Re: Variance Petition
Oak-Land Middle School Additions Project
Lake Elmo, MN

MEMORANDUM

To: Minnesota State Plumbing Board Date: December 10, 2024
From: Larson Engineering, Inc. Project No: 12246044
Project: Oak-Land Middle School Additions & Renovations
Re: Variance Regarding 2020 Minnesota Plumbing Code Section 310.5

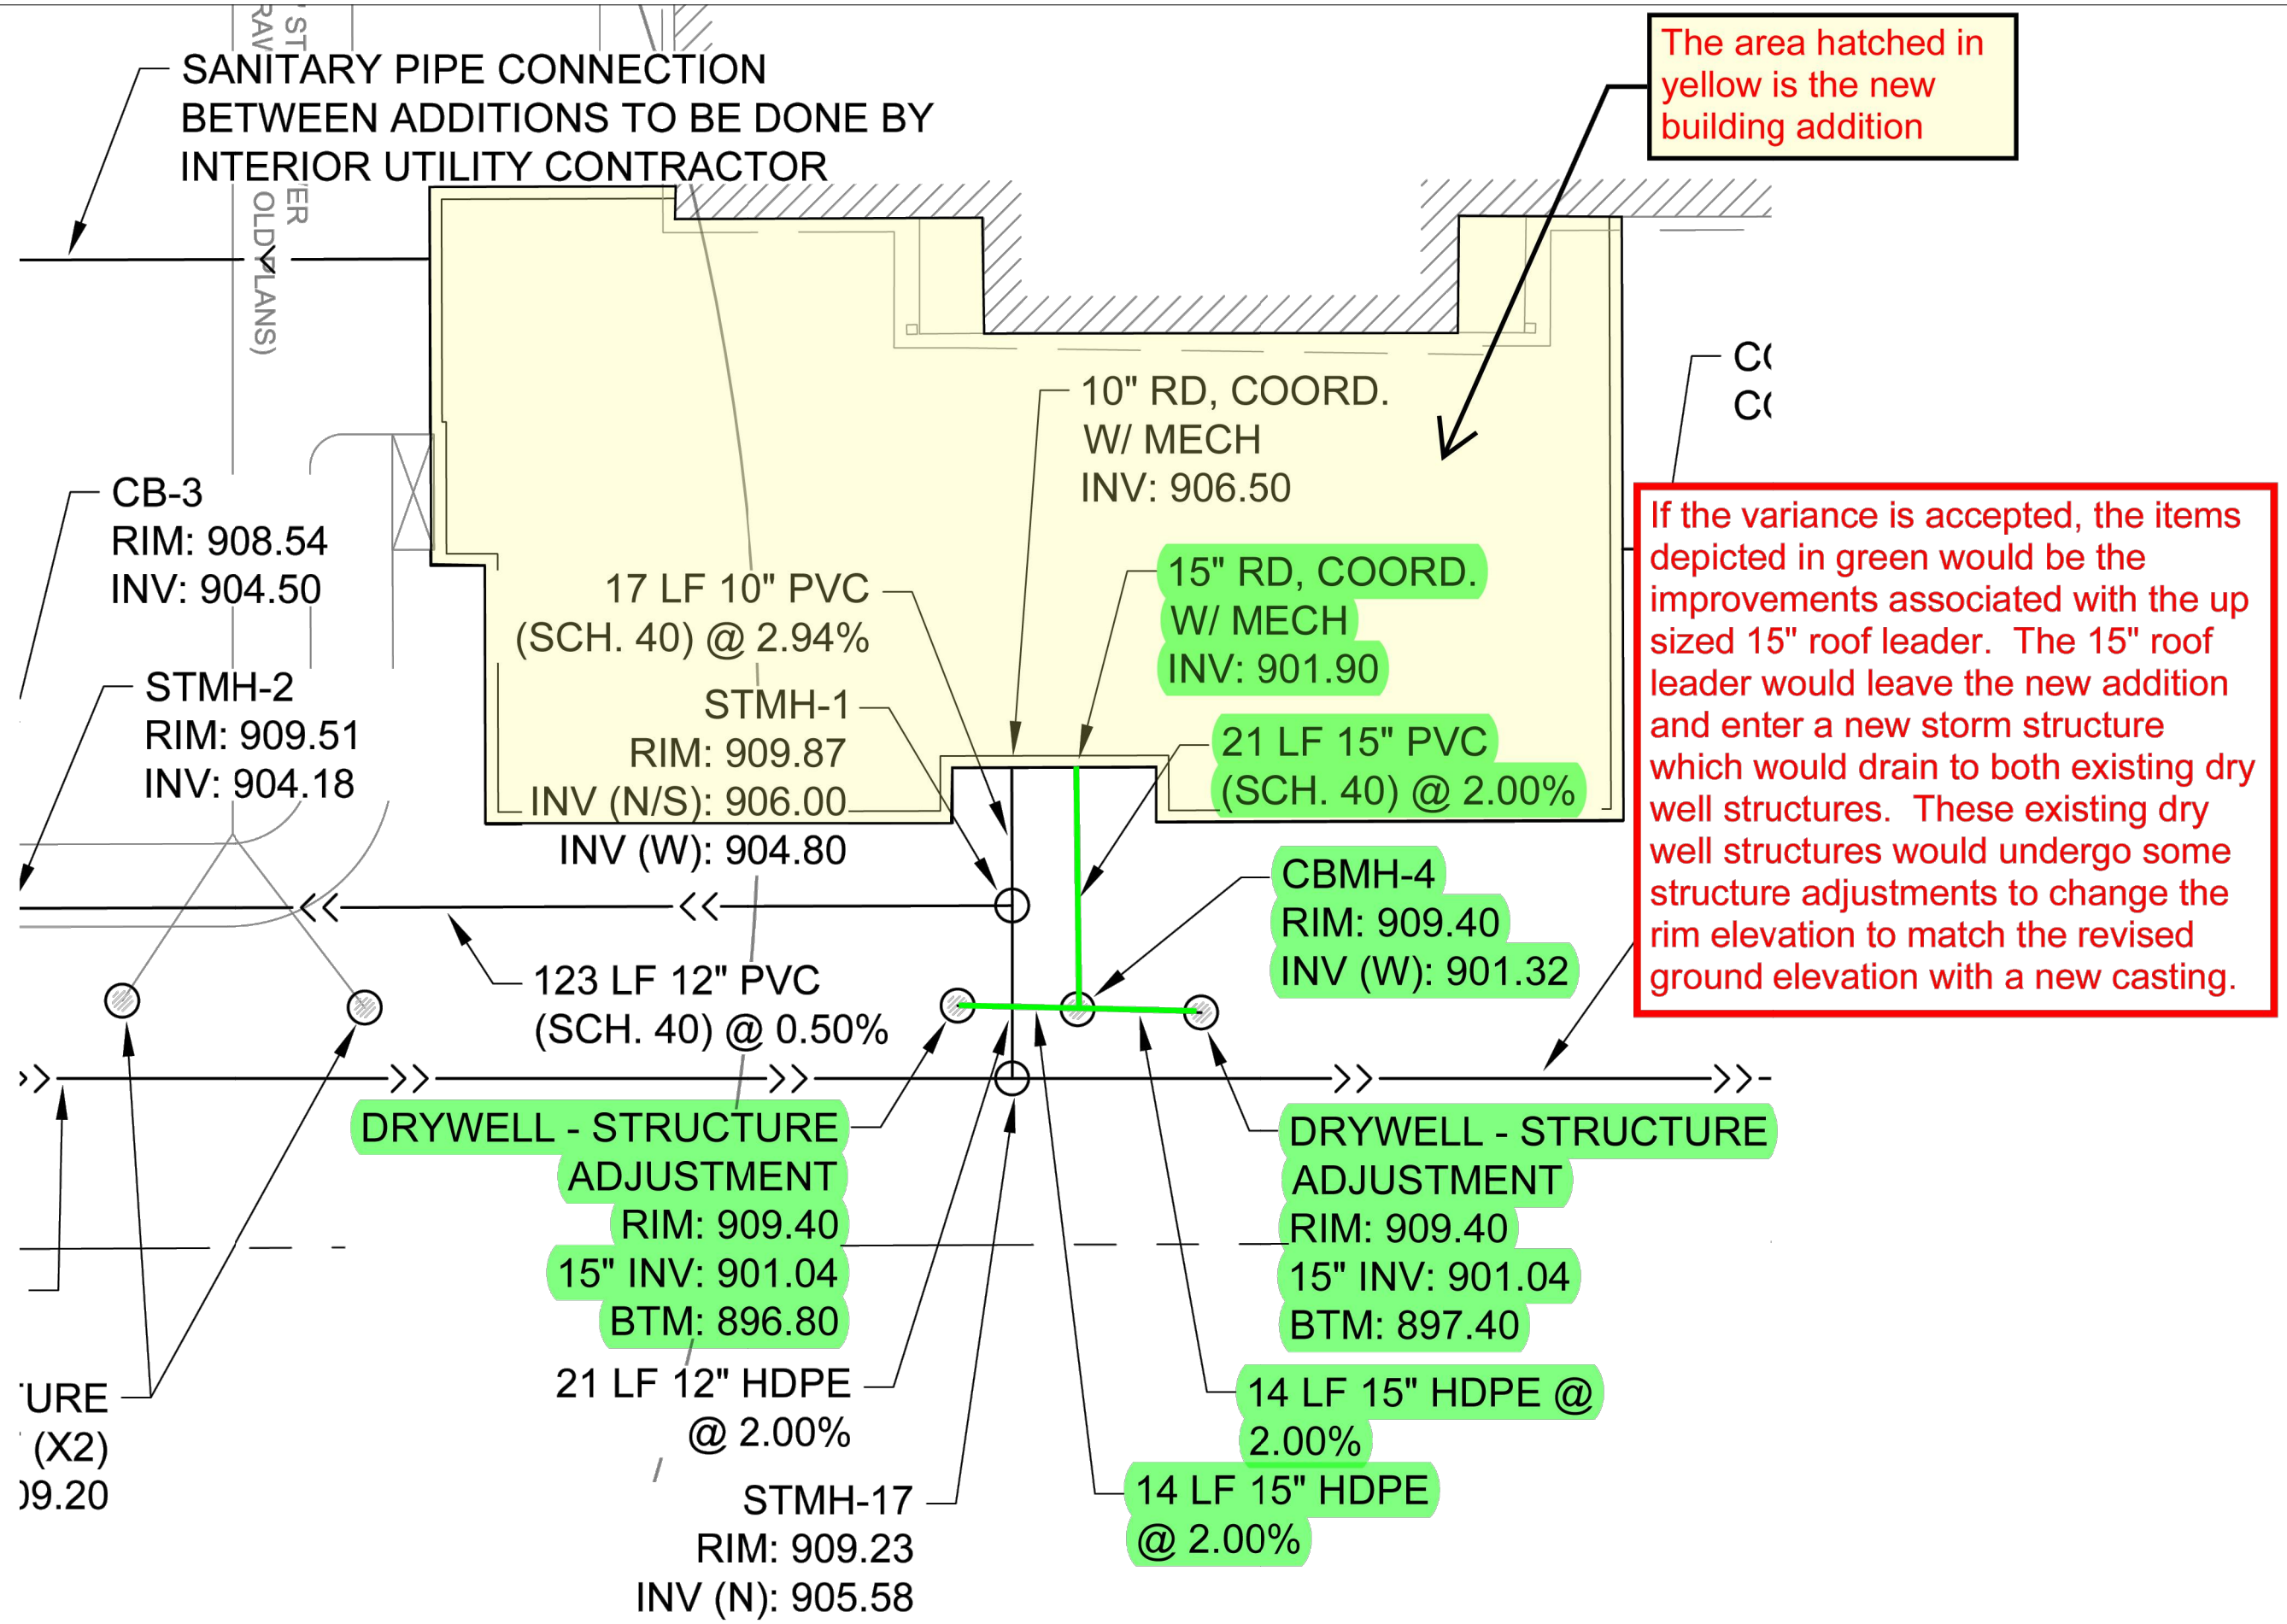
The existing roof leader leaves the building at an elevation of 903.65.
 (Note: the lowest elevation that storm water leaves the site is at an elevation of 902.3 and is located roughly 520' away to the southeast)

Existing routing for 8" roof leader pipe in question.

Existing Dry Wells, if the variance is accepted these would remain in place and undergo some maintenance improvements.

The blue box depicts the area represented in Exhibit #5, this exhibit shows all the conflicts restricting the mechanical contractor from raising the existing roof leader pipe within the building

Exhibit #4 depicts the routing of the roof leader under the new school addition

EXHIBIT #3 - ROOF DRAINAGE

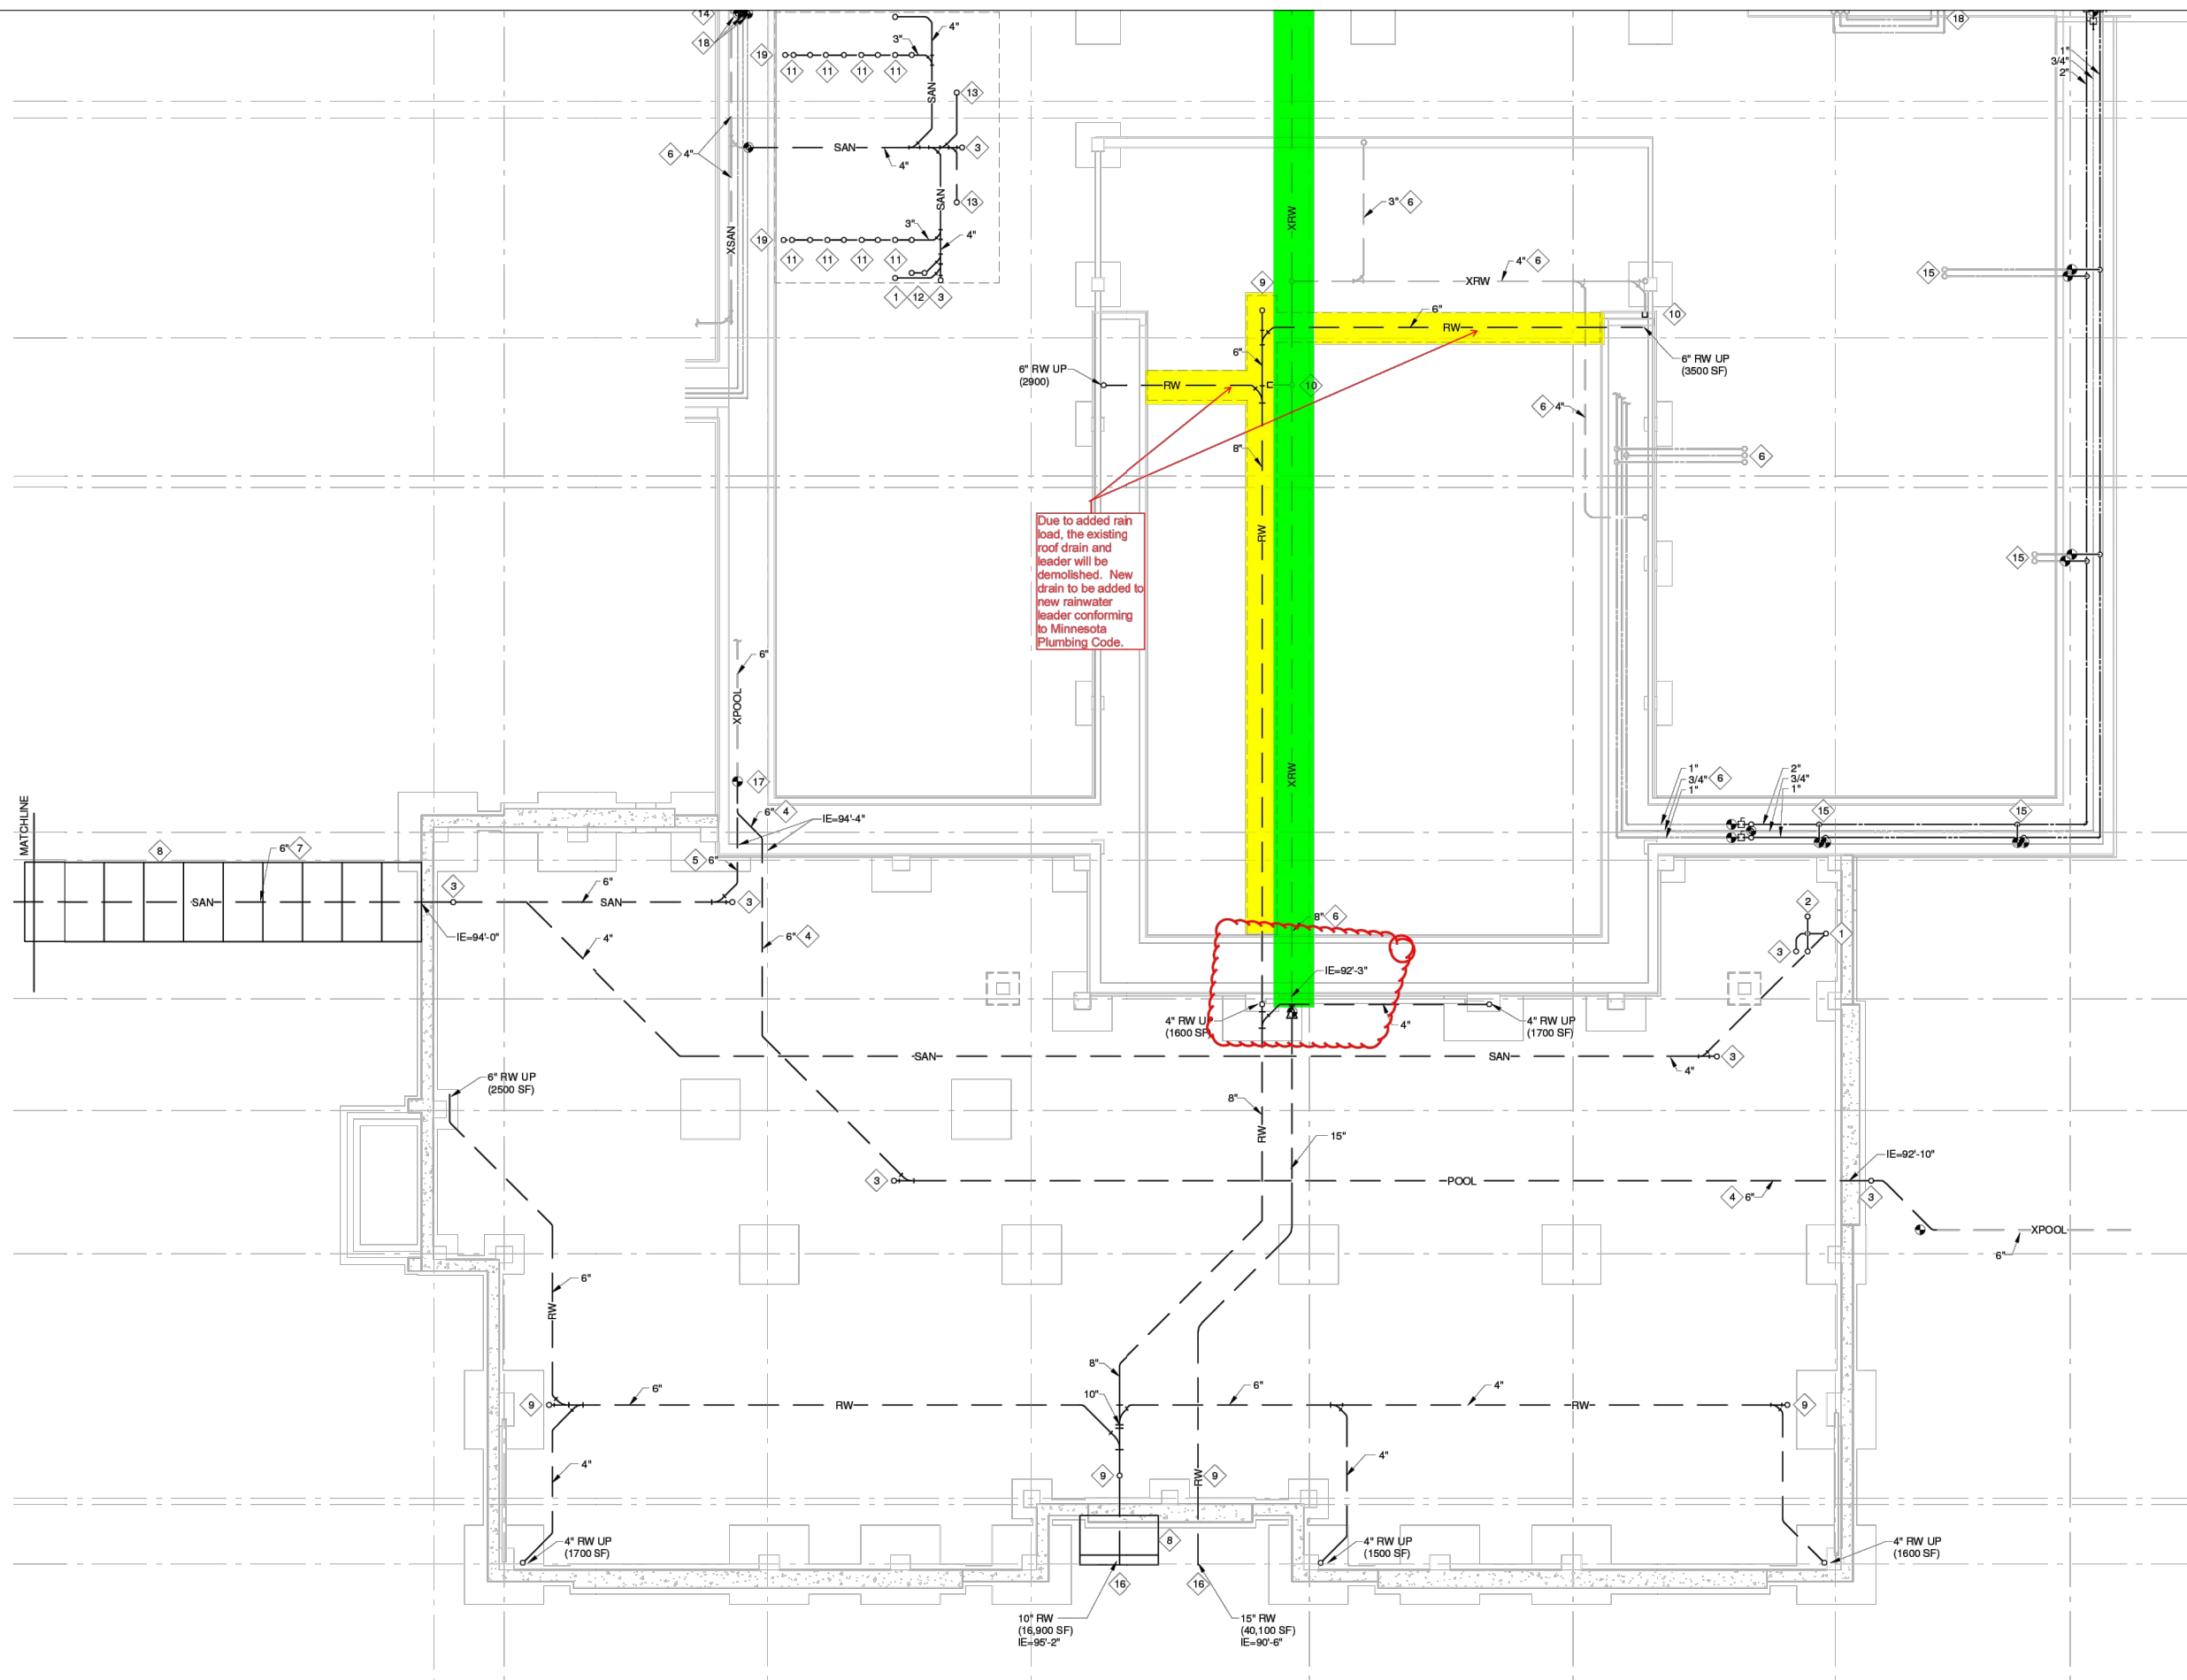
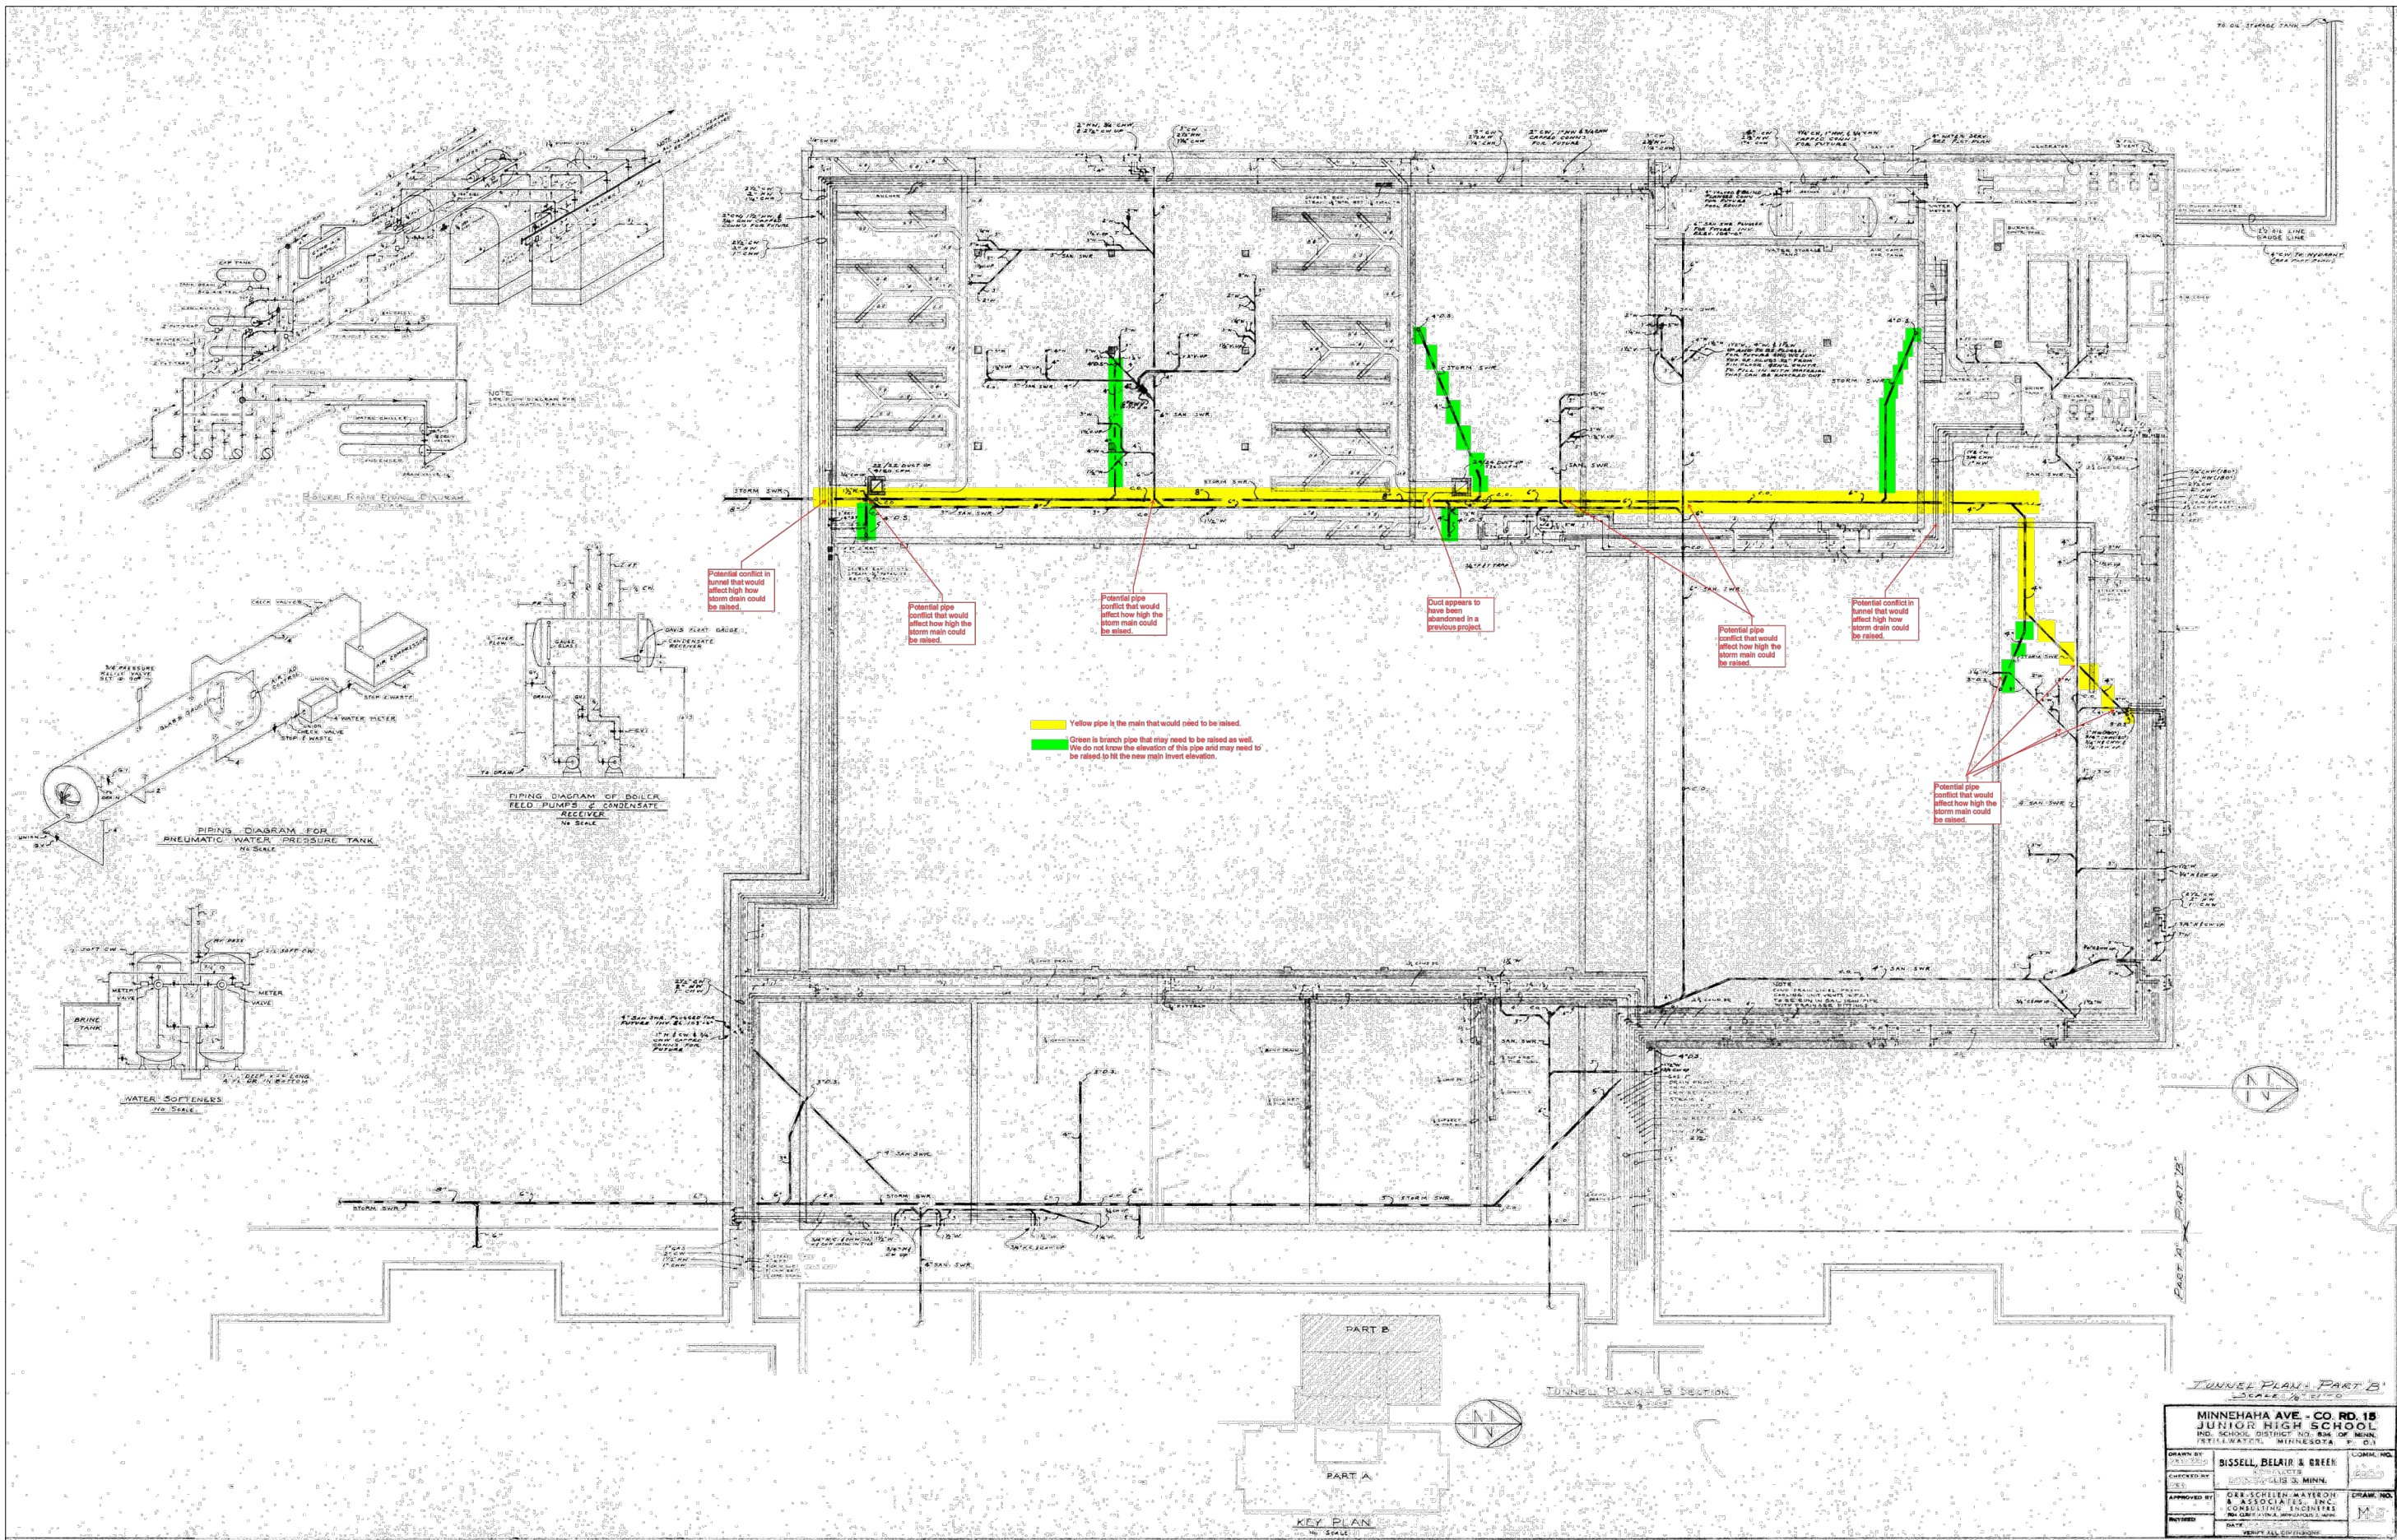
The red hatch depicts the area of the existing roof that will leave out the up sized 15" roof leader (existing conditions have this as an 8" roof leader)

The orange hatch depicts the area of the existing roof that is being re-routed to a new roof drain leaving the new addition out of a new 10" roof leader

The yellow hatch depicts the area of new roof leaving out the 10" roof leader

New 10" roof leader, this services the new addition and some of the existing roof - orange areas

15" up sized roof leader, this services the existing roof and leaves the building at a significantly lower elevation (901.9)
